Development Facilitation Team (DFT) – Review Comments

Project No: PR-2024-010462 Date: 6/26/2024 Agenda Item: #6 Zone Atlas Page: G-14

Application For: SD-2024-00104 – PRELIMINARY/FINAL PLAT

Project Name: 210 Candelaria Rd NW

FIGURE 7.2.41 Street Element Dimensions Along Major Roads

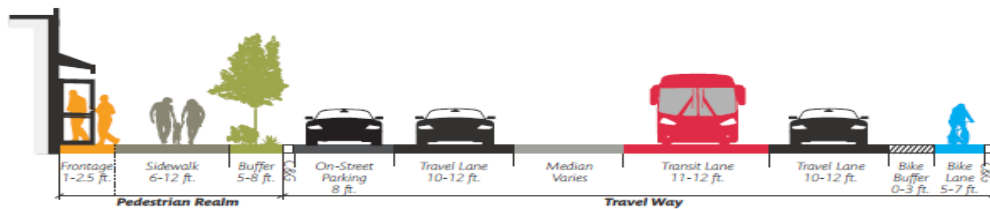
Candelaria is a Principal Arterial and requires 6' sidewalk with a 5' to 6' landscape buffer. Planning has received an IL showing the 6' foot sidewalk will be built.

Confirm compliance with the 5-6' landscape buffer along Candelaria.
